TOWN OF MILFORD, NH
OFFICE OF COMMUNITY DEVELOPMENT

Date: October 11, 2022
To: Planning Board
From: Camille Pattison, NRPC Assistant Director
Subject: SP2022-08 Sooner Transportation LLC, for the property located at Tax Map 12, Lot 11, 754-756 Elm Street (Horseless Carriage Site). Public Hearing for a Major Site Plan Application to construct a two-story, 10,320 sf. auto sales and repair facility with associated parking, stormwater management/drainage, landscaping, and lighting improvements on the subject property located in the Commercial ‘C’ Zoning District and West Elm Overlay District.

**Re: Sooner Milford Site Plan (Tax Map 12, Lot 11) – 754 and 756 Elm Street
Site Plan Drainage Review**

SOONER MILFORD SITE PLAN

SCALE: 1" = 20'
 APRIL 25, 2022
 SHEET 10 OF 12

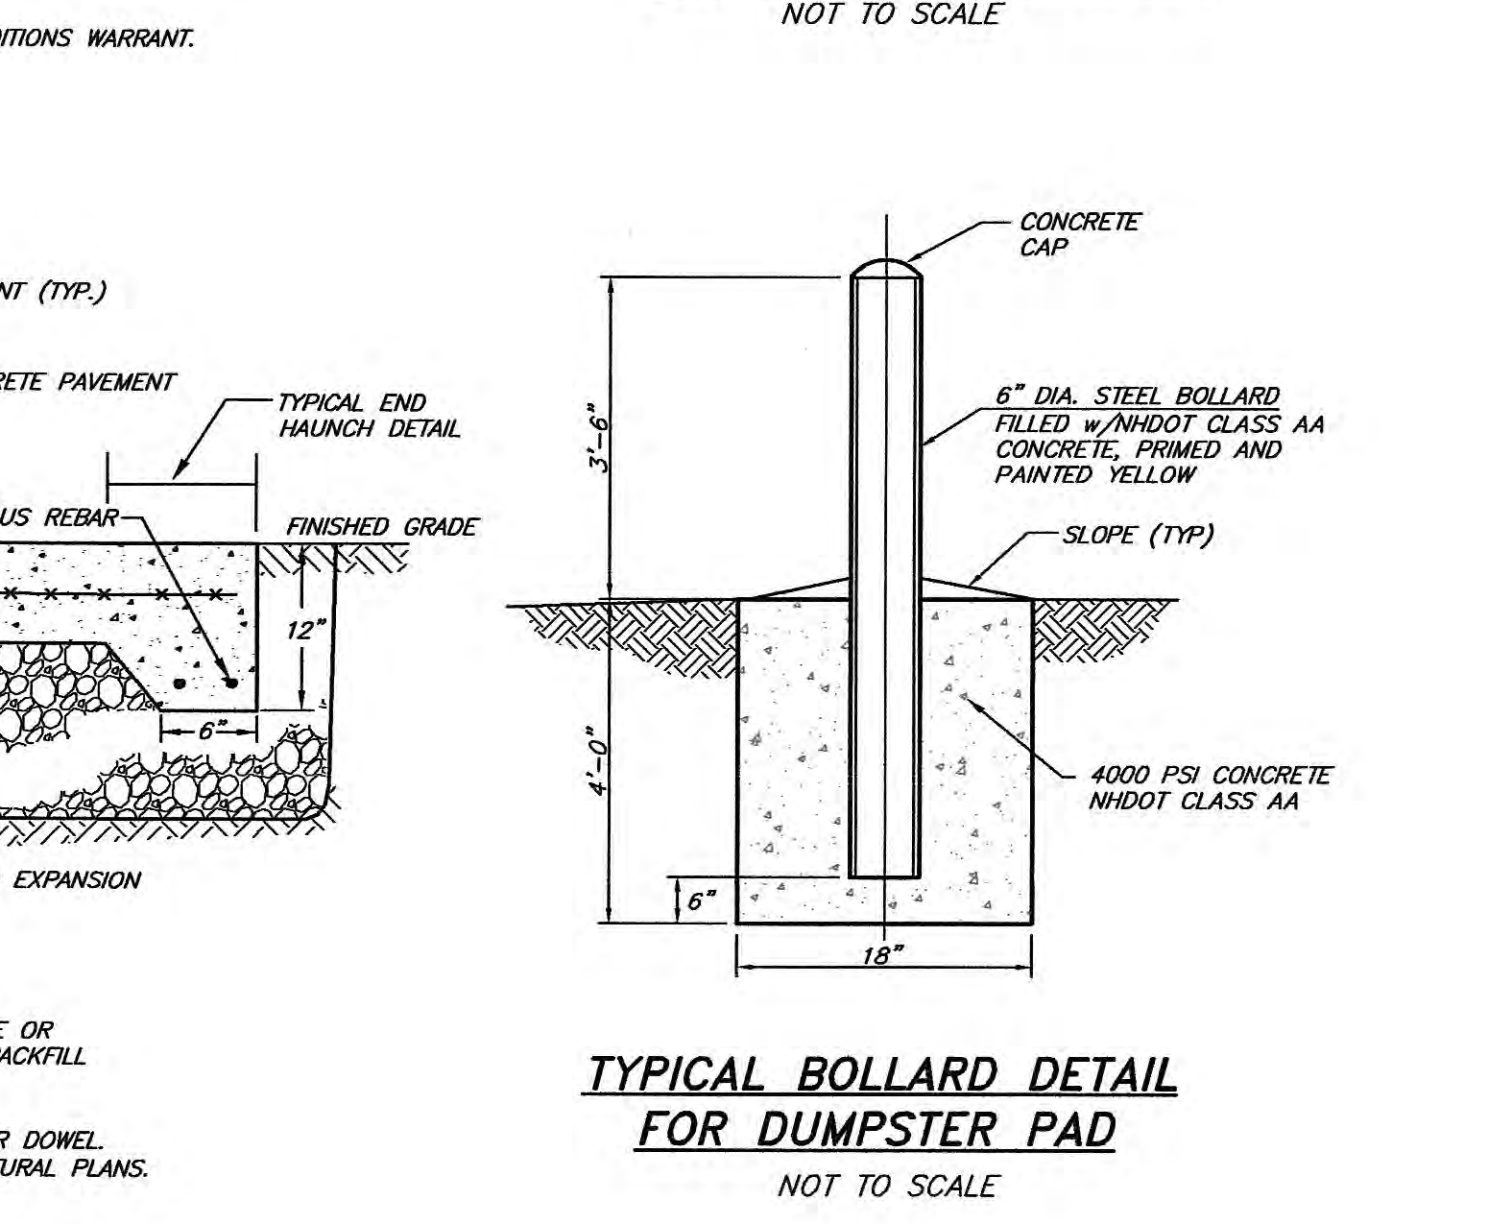
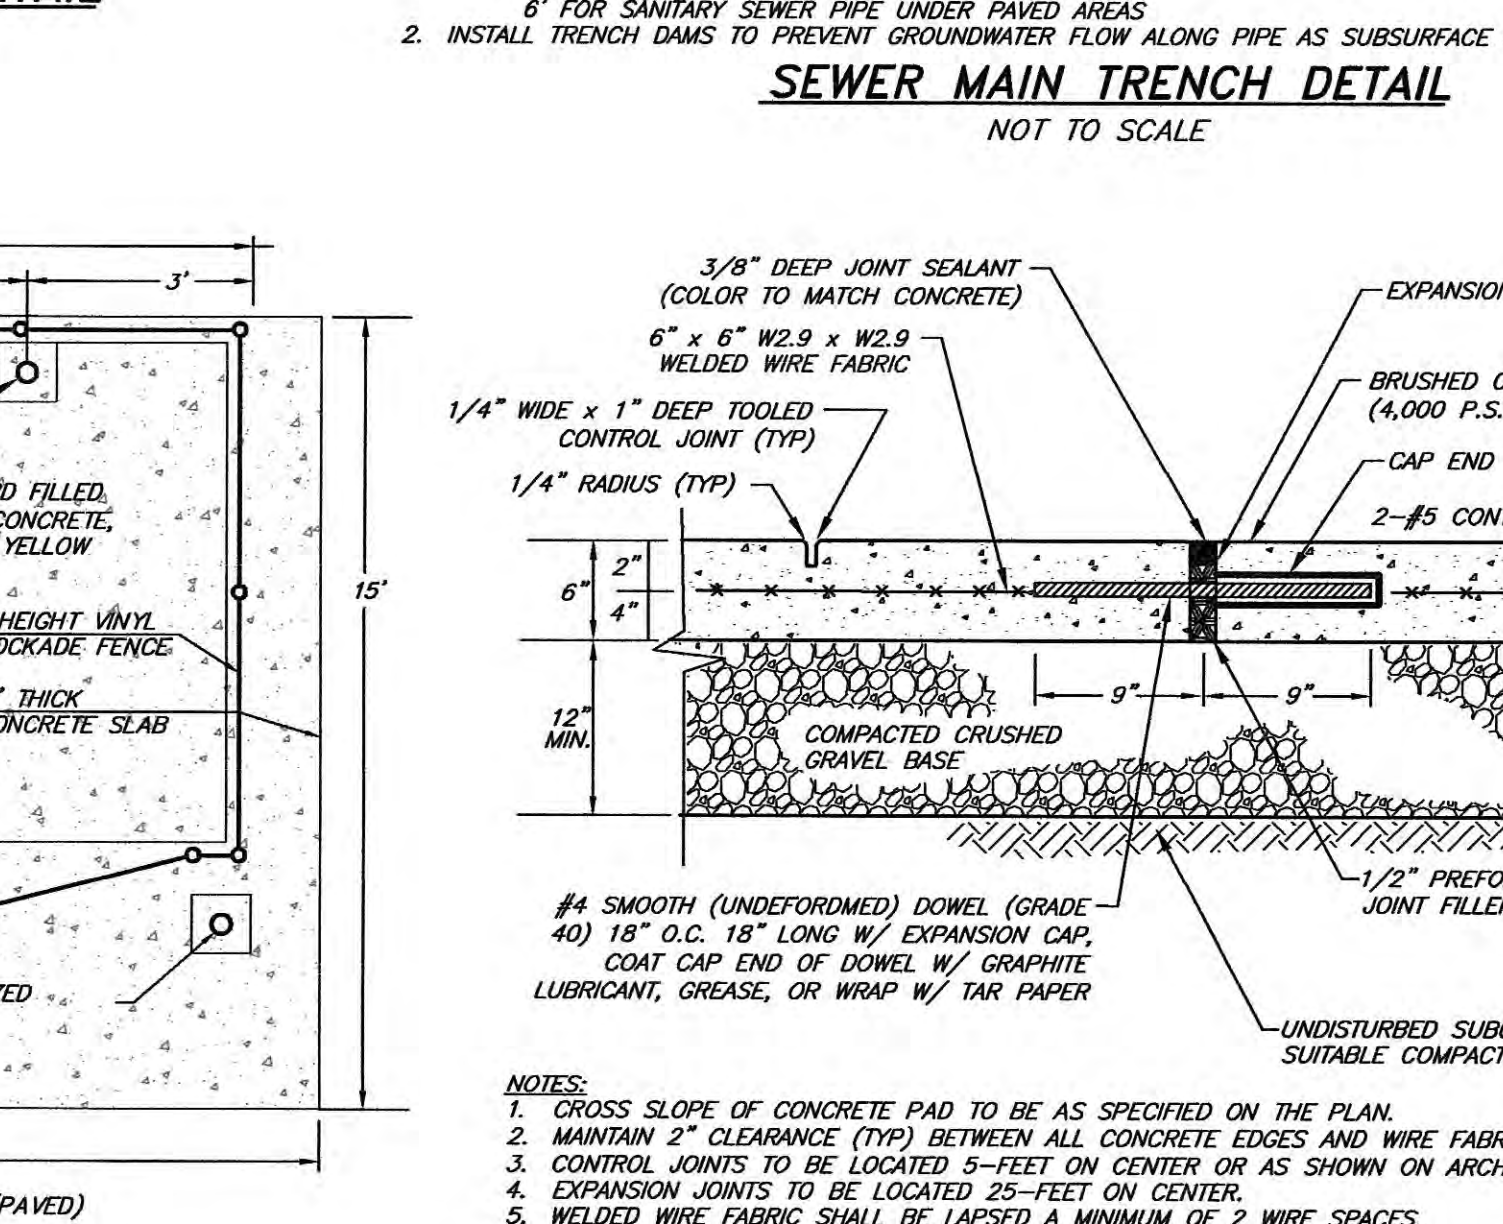
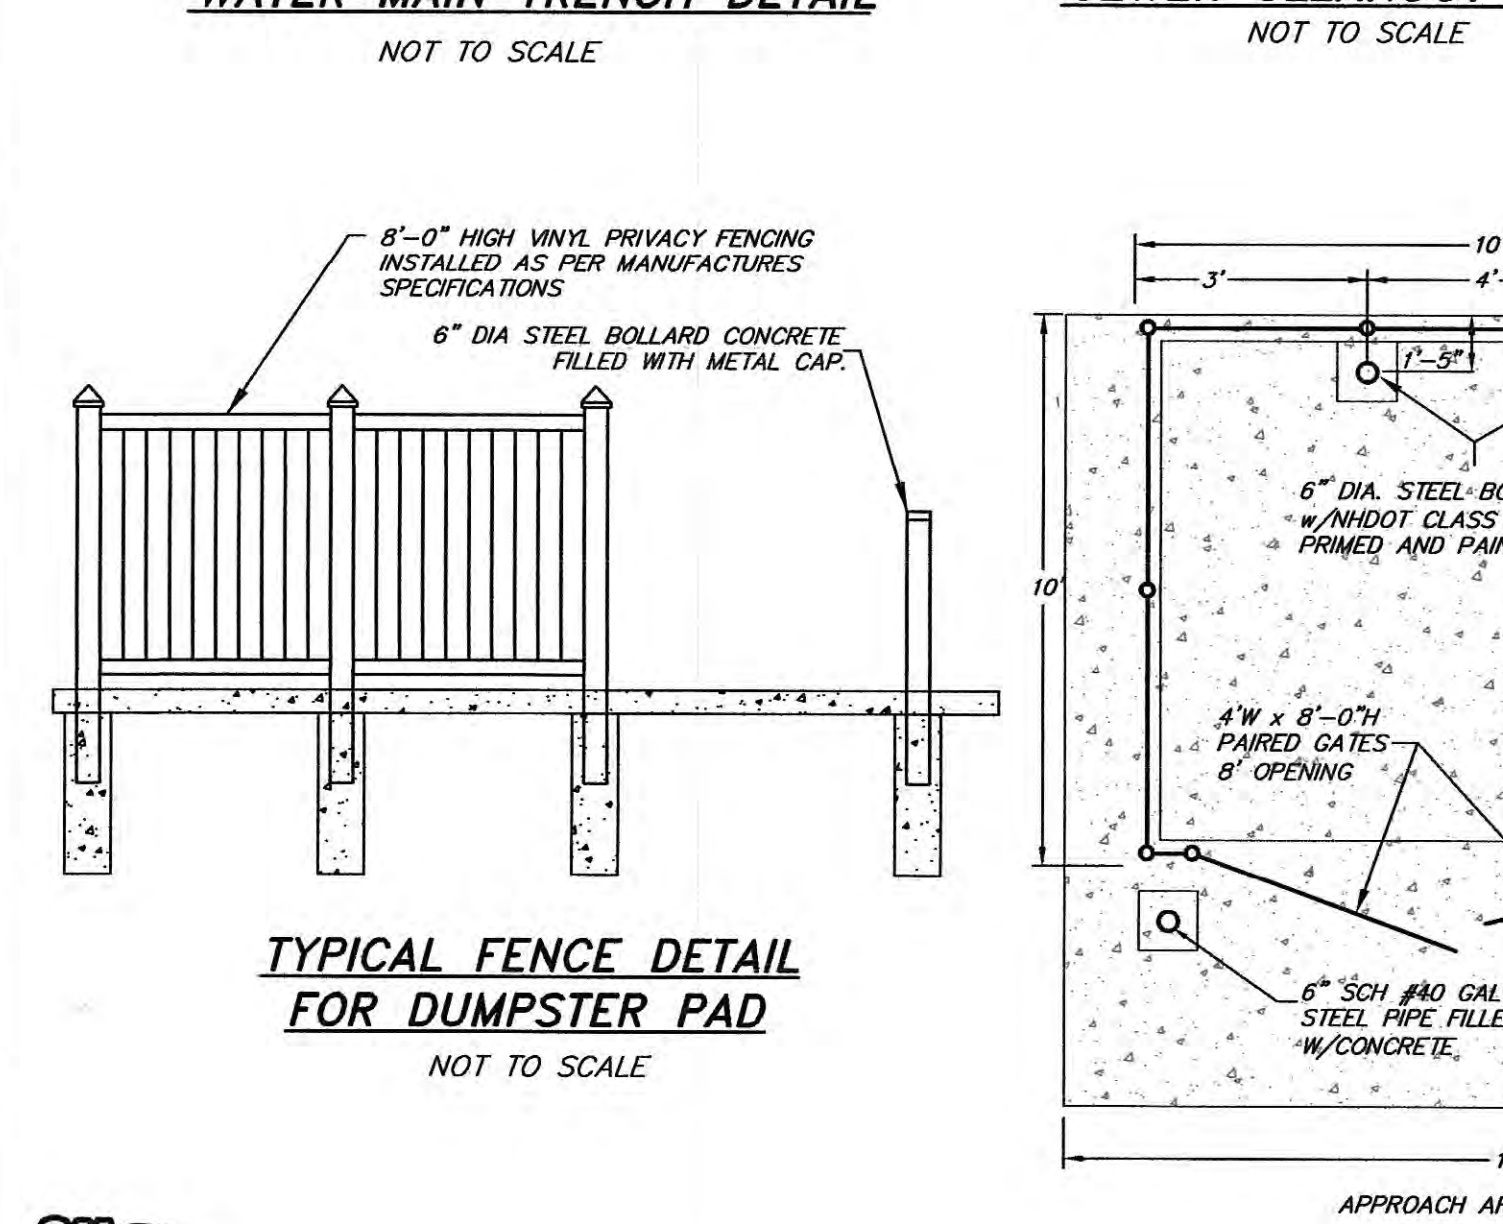
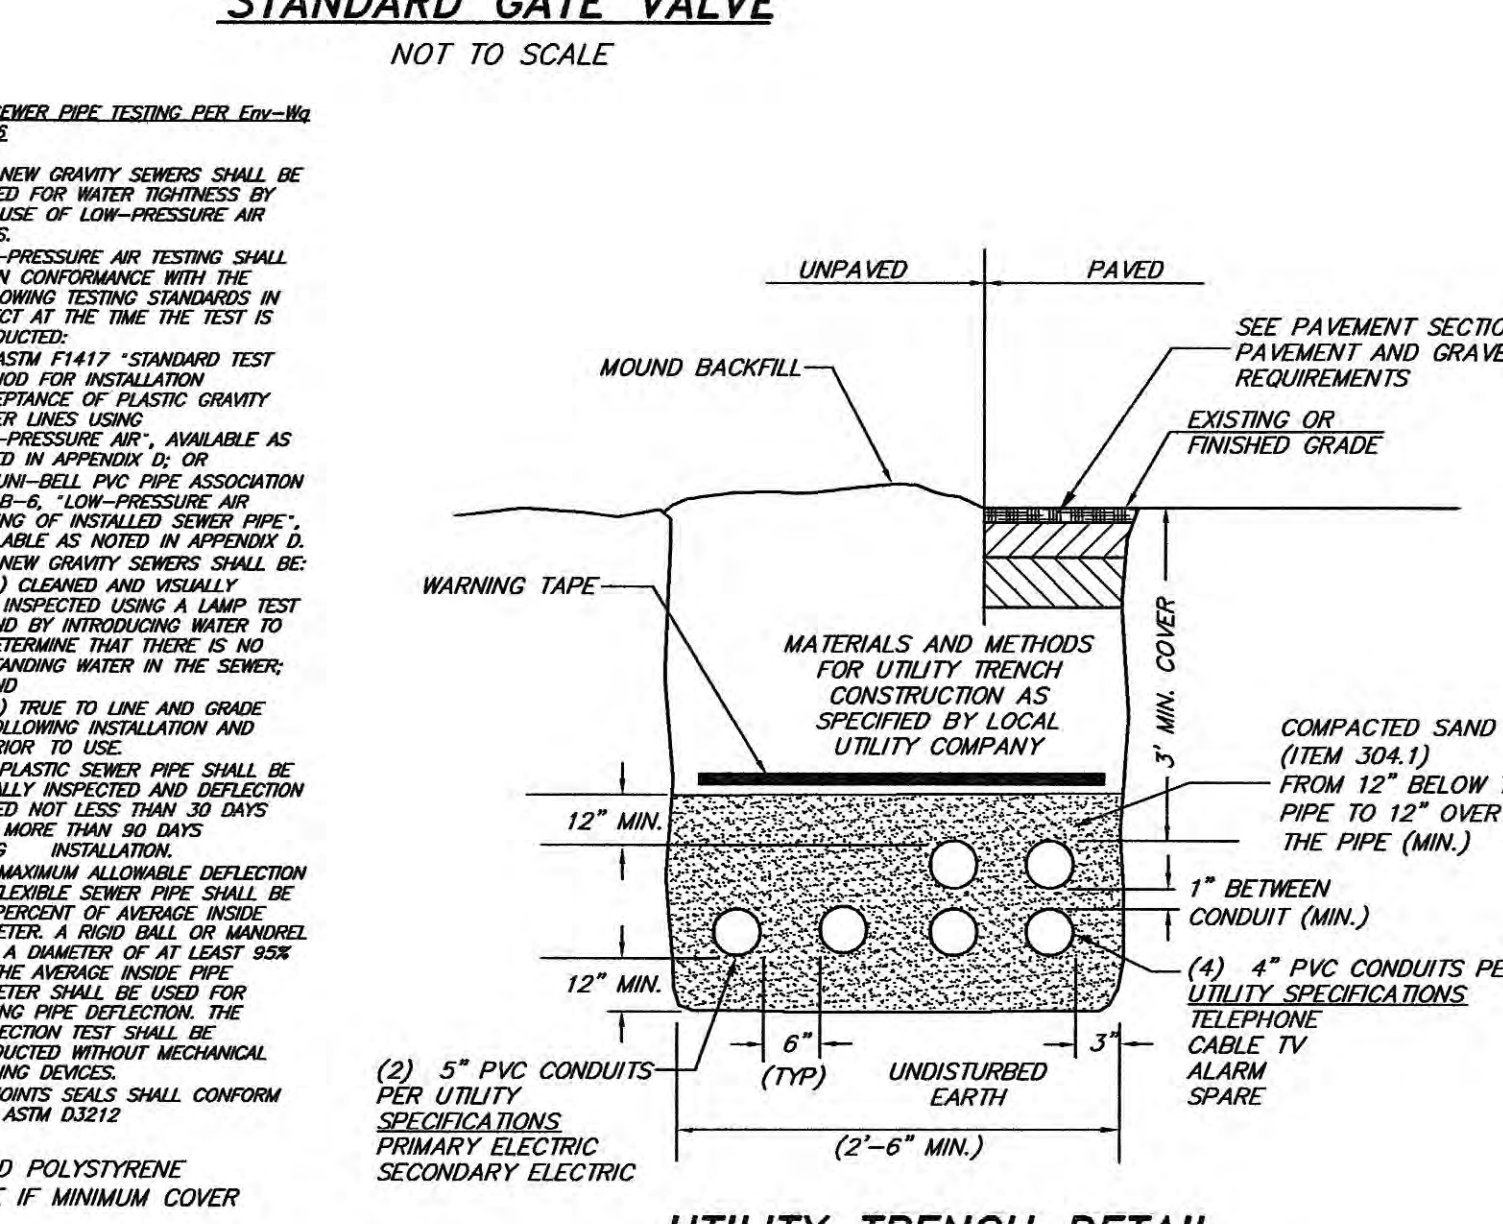
9. Please revise site plan to include all proposed signage for the project. *Resolved*
10. Sheets 1 and 10 – The site plan shows the proposed location of the dumpster and pad encircled by an 8' stockade fence within the 15-foot westerly side dimensional setback. The proposed 8' stockade fence and concrete pad are defined as structures in the Town's Zoning Ordinance and such, would require a Special Exception by the Board of Adjustment for relief of this requirement. The alternative would be amending the plan and relocate the dumpster outside of the dimensional setback. *Resolved*

10. Sheets 1 and 10 – The site plan shows the proposed location of the dumpster and pad encircled by an 8' stockade fence within the 15 foot westerly side dimensional setback. The proposed 8' stockade fence and concrete pad are defined as structures in the Town's Zoning Ordinance and such, would require a Special Exception by the Board of Adjustment for relief of this requirement. The alternative would be amend the plan and relocate the dumpster outside of the dimensional setback.
